PLANNING COMMISSION AGENDA
Tuesday, December 5, 2023 6:30 p.m.
Council Chambers, 209 S. Main Street, 2nd Floor

RE: Planned Unit Development Review – Marysville East Section 2

PUD Development Plan Submittal – November 14, 2023

BUFFER OPTION B

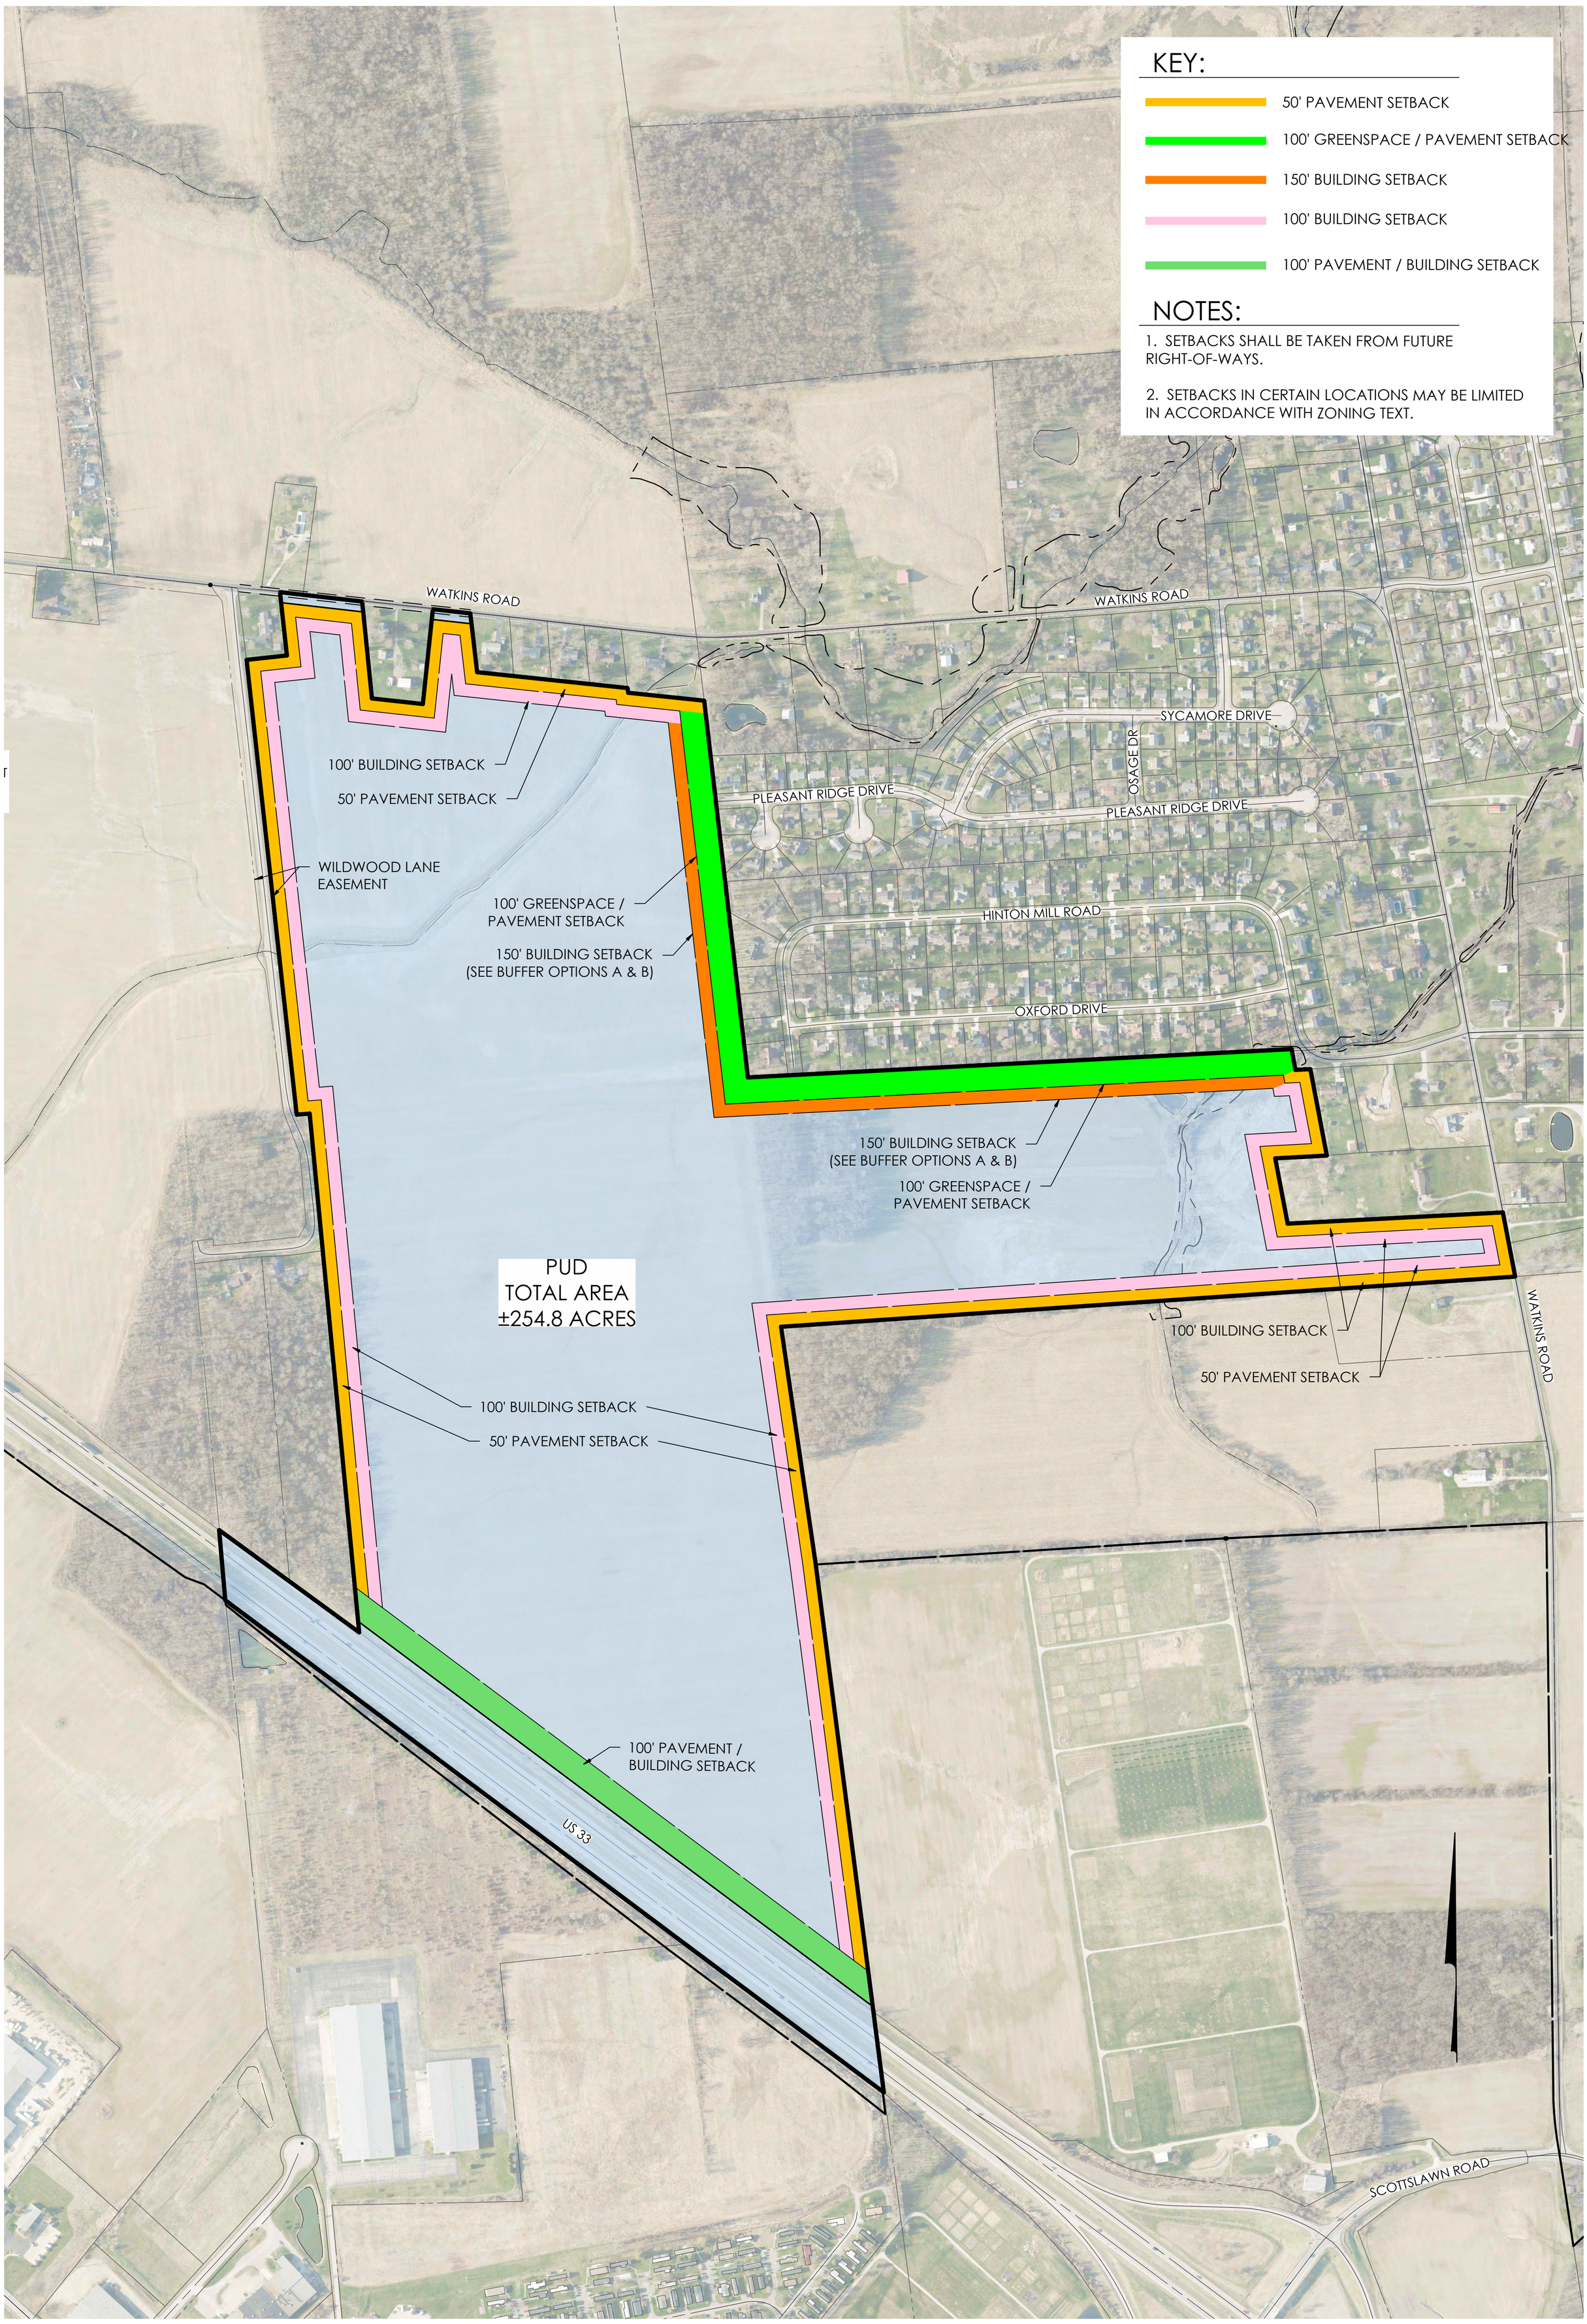
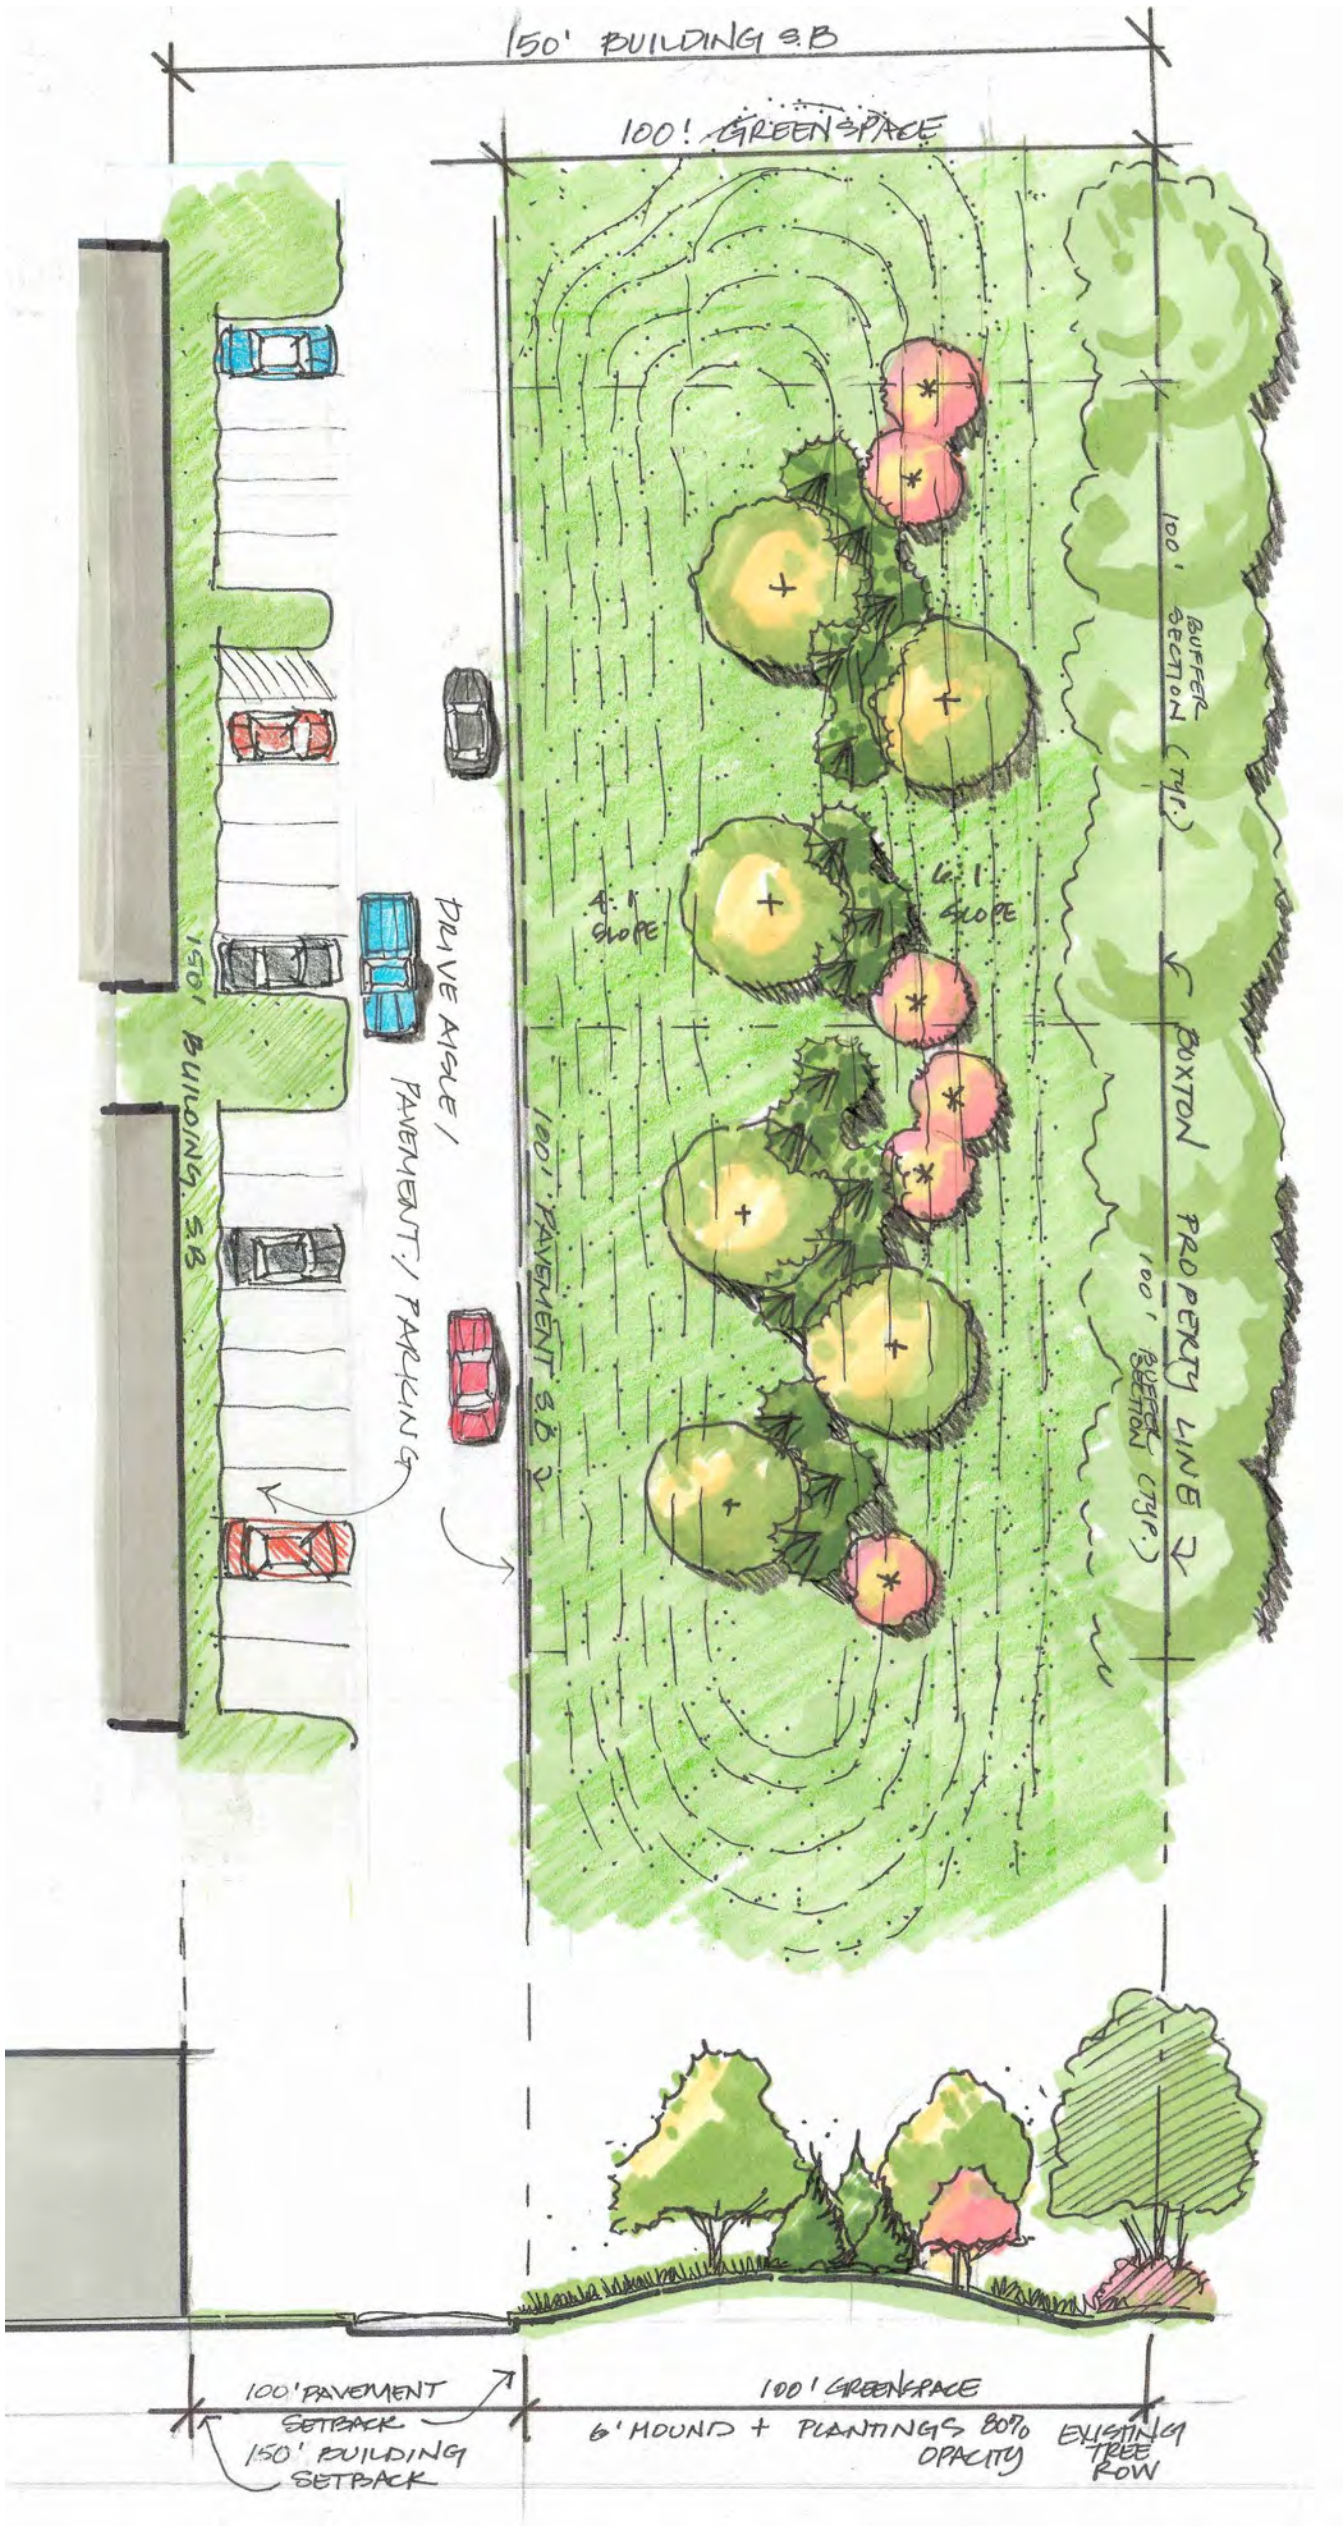
The applicant shall provide exhibit/s of the proposed Perimeter Landscape depicting the mound with the mixture of the planting, or indicate which buffer exhibit to refer to for a depiction of the screening requirements in the development text of the perimeter landscape standards section.

8. The applicant shall provide exhibit/s of the proposed Perimeter Landscape depicting the mound with the mixture of the planting, or indicate which buffer exhibit to refer to for a depiction of the screening requirements in the development text of the perimeter landscape standards section.
